DILLINGHAM AIRPORT CHEMICAL STORAGE BUILDING

AIRPORT IMPROVEMENT PROGRAM
A.I.P. NO. 3-02-0078-011-2009

STATE PROJECT NO. 50928

RECORD DRAWING

A SITE PLAN

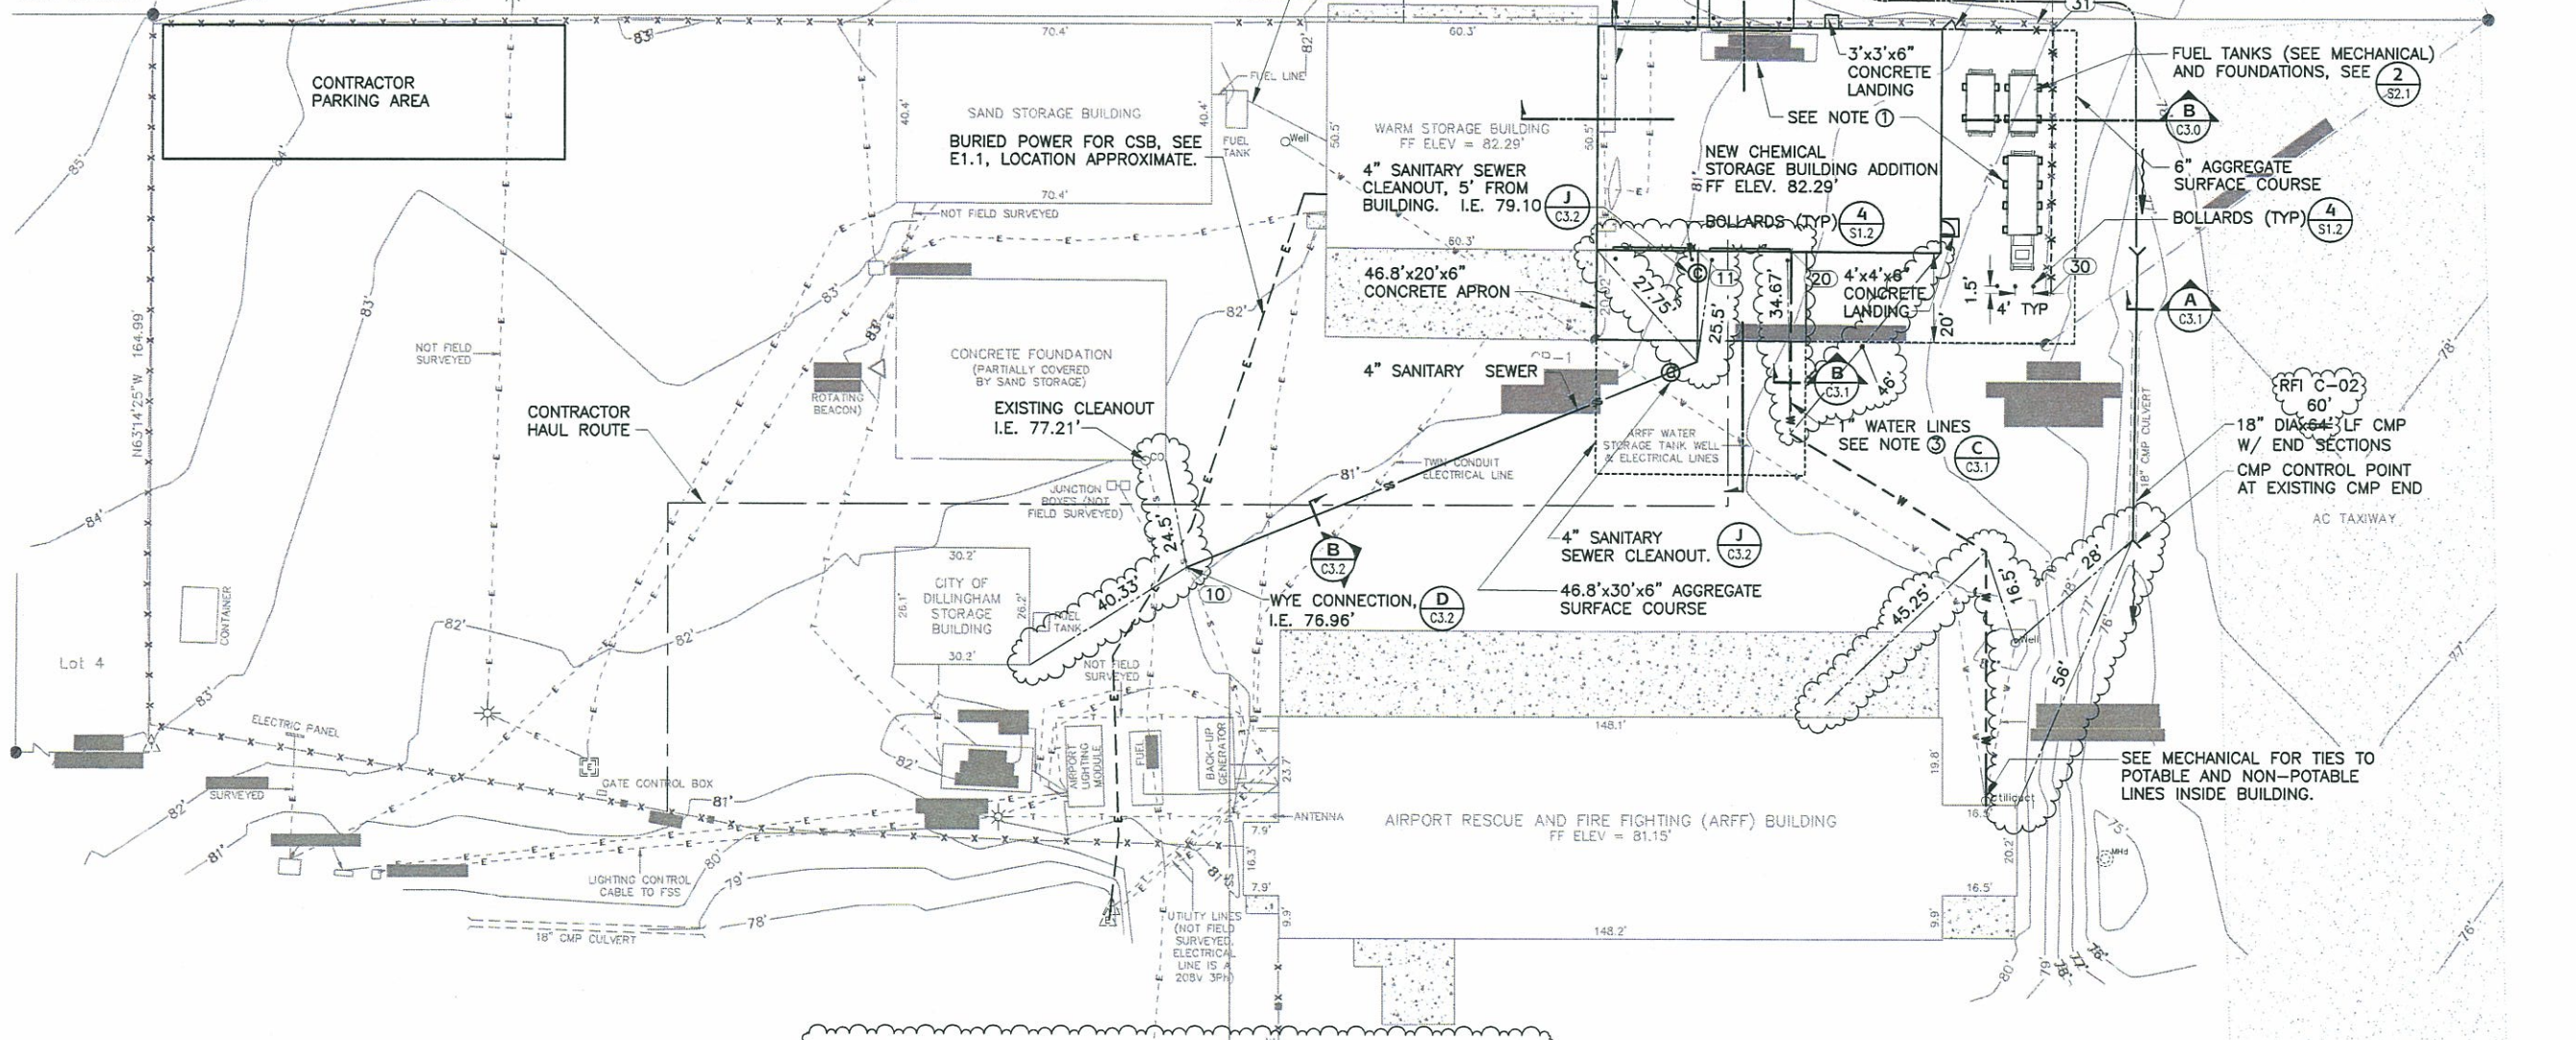
ITEM 14, ADDENDUM 1:

THE WATER SERVICE TO THE EXISTING ARFF BUILDING IS SERVED BY TWO WELLS, ONE NON-POTABLE WELL LOCATED BETWEEN THE WARM STORAGE AND SAND STORAGE BUILDINGS AND ONE POTABLE WELL APPROXIMATELY 35' WEST OF THE NW CORNER OF THE ARFF BUILDING. EACH WELL HAS A WATER LINE THAT IS BURIED A MINIMUM OF 8' FT BELOW GRADE LEVEL. THE NON-POTABLE WATER LINE ENTERS THE ARFF BUILDING ABOVE GRADE LEVEL THROUGH A WALL PENETRATION WITHIN AN EXTERIOR INSULATED COVER OVER AN 8' FT VERTICAL SECTION OF UTILITY LOCATED ALONG THE WEST WALL OF THE ARFF BUILDING. THE NEW PIPING FOR THE CHEMICAL STORAGE BUILDING WATER SERVICE SHALL EXIT THE ARFF BUILDING WALL AT THIS SAME LOCATION AND EXTEND DOWN THROUGH THE EXISTING VERTICAL SECTION OF UTILITY WHERE IT WILL BE ROUTED TOWARDS THE NEW CSB AS INDICATED ON SHEET C2.0 OF THE CONTRACT DRAWINGS. NO DEMOLITION OF EXISTING CONCRETE IS ANTICIPATED FOR THIS WORK ITEM.

ITEM 2, ADDENDUM 2:

DEPARTMENT WILL MOVE TANK FT-3 TO TEMPORARY LOCATION WITHIN ADOT'S FENCED YARD PRIOR TO CONTRACTOR MOBILIZING ON SITE. CONTRACTOR SHALL BE RESPONSIBLE FOR MOVING TANK FT-3 FROM TEMPORARY LOCATION TO NEW TANK FOUNDATION, REF A/C2.0 & 1/S2.1. CONTRACTOR SHALL NOTIFY DEPARTMENT A MINIMUM OF 3 WEEKS PRIOR TO MOVING TANK. CONTRACTOR SHALL BE RESPONSIBLE FOR EMPTYING FUEL TANK PRIOR TO MOVE AND SUPPLYING A TEMPORARY DIESEL DISPENSING TANK (MINIMUM 500 GAL CAPACITY WITH ELECTRIC DISPENSING SYSTEM FOR DEPARTMENT'S USE) DURING THE TIME PERIOD WHERE TANK FT-3 IS INOPERABLE OF OTHERWISE NOT AVAILABLE FOR USE BY THE DEPARTMENT. SEE ADDENDUM ITEM 10.

THESE POINTS ARE INCORRECT
